OBJECTIONS to planning application 2020/4086/P - 155 Drummond Street London NW1 2PB

As you will be aware, the planning application proposes the partial demolition of the existing four-storey residential building at 155 Drummond Street and the erection of a six-storey residential building with a terrace at roof level.

APPENDIX 1 – DAYLIGHT OUTLOOK FROM FLAT 14

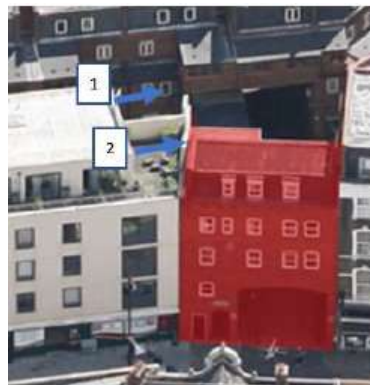
My residence is on the fourth floor of 141-153 Drummond Street which borders 155 Drummond Street. You will see from the images in Appendix 1 of this letter that Flat 14 has a roof terrace, the western wall of which is approximately 2m at its highest point and is part of a party wall with 155 Drummond Street. You will also see that the roof terrace and the western facing windows of the living room and bedroom currently benefit from high levels of daylight and afternoon sunlight.

The sections of the proposed scheme shown on the application drawing P23A indicate that the proposed development will double the length of the western wall, as well as increase the height of the western wall across its entire length by some 6m. This will obviously block out a large proportion of the **daylight and afternoon sunlight** currently received by roof terrace and the western facing windows of the living room, as well as the sole window to the bedroom.

It will also be a hugely **overbearing presence** for users of the roof terrace and when viewed from these windows, severely impacting the current open outlook.

Although the position and height of the proposed development in relation to Flat 14 clearly fails the Building Research Establishment's 45-degree and 25-degree tests for requiring a daylight and sunlight report¹, the applicant has not submitted such a report as part of the current proposal. A previously withdrawn application by the applicant had concluded that there would be significant reduction in daylight to the western bedroom. Without a daylight and sunlight report it is not possible to quantify the extent of the newly proposed development's impact on the daylight and sunlight levels currently received by Flat 14's terrace and western facing windows.

APPENDIX 2 – VIEWS SHOWING 155 DRUMMOND STREET IN CONTEXT OF PREVAILING BUILDING SCALE

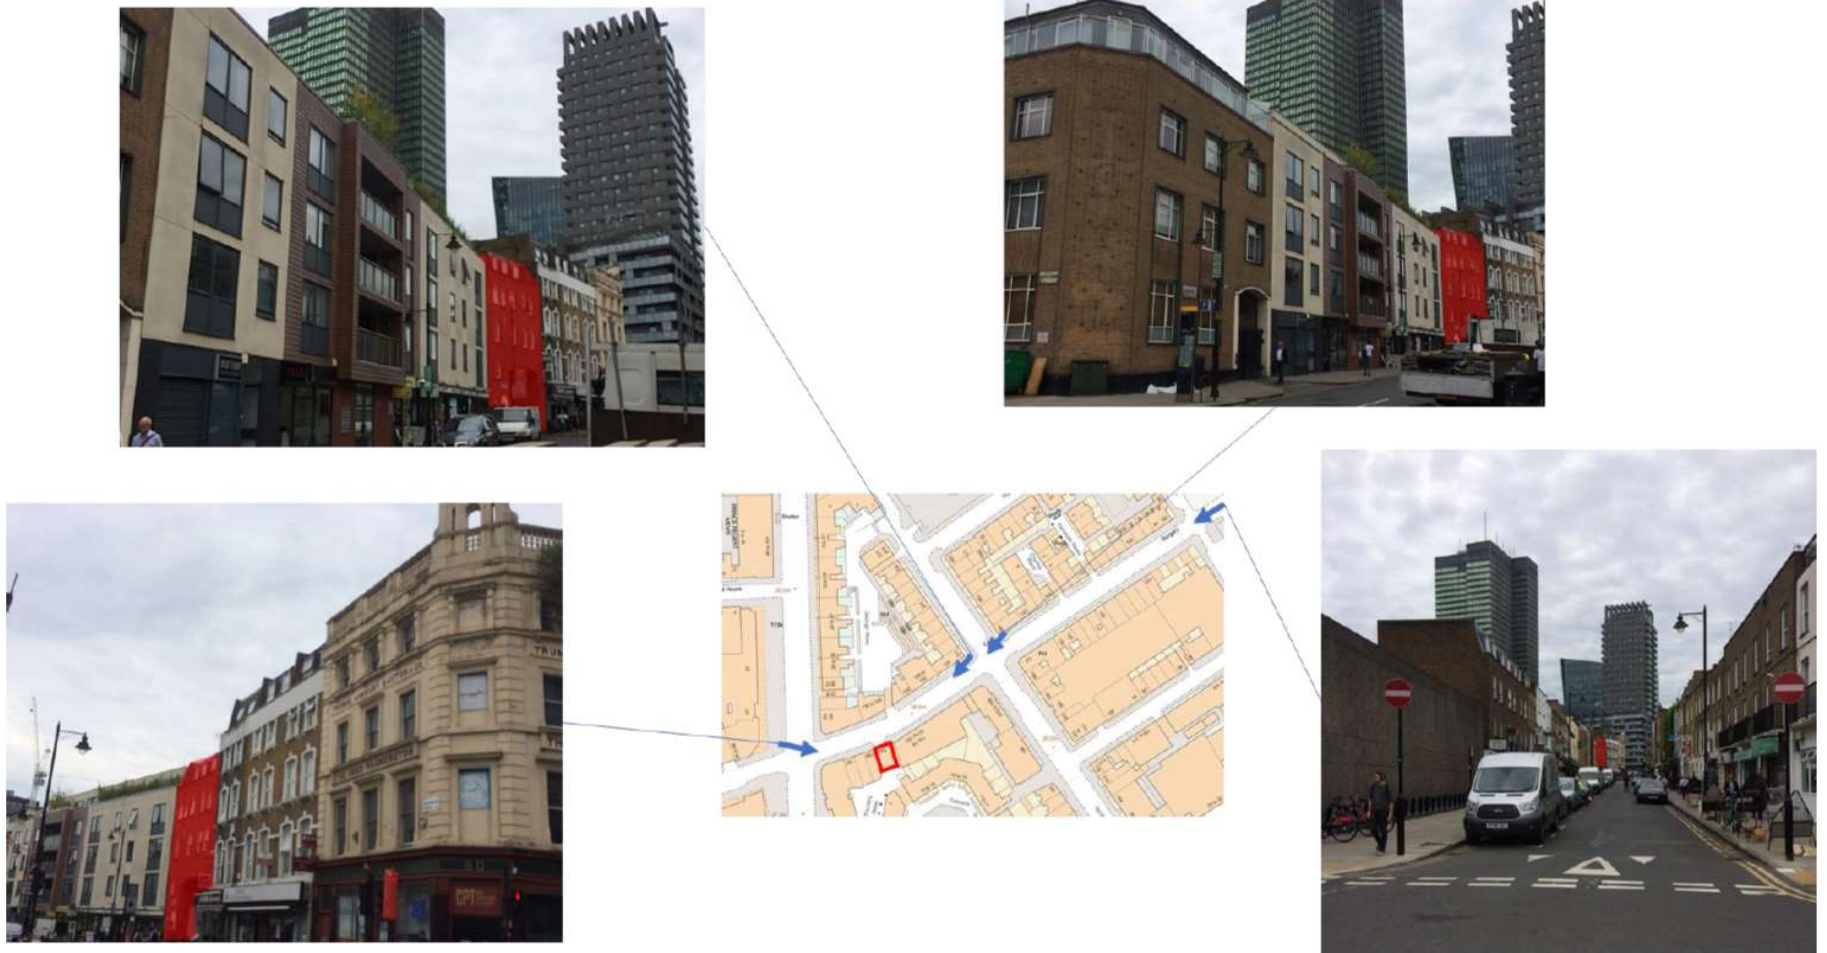
You will see from the images in Appendix 2 that Drummond Street is characterised by a prevailing urban scale of **three to four storeys**. The importance of maintaining this distinctive scale is recognised on page 100 of the Euston Area Plan (Jan 2015) adopted in 2015 by Camden Council and the Greater London Authority²:

We therefore **object** to the proposed development plans to introduce a 6-storey building with a roof terrace, which clearly does not maintain or respect the prevailing three to four storey building height and scale of Drummond Street. As such it is not in accordance with the *Euston Plan (2015)* or policy D1a of the *Camden Local Plan (2017)*.
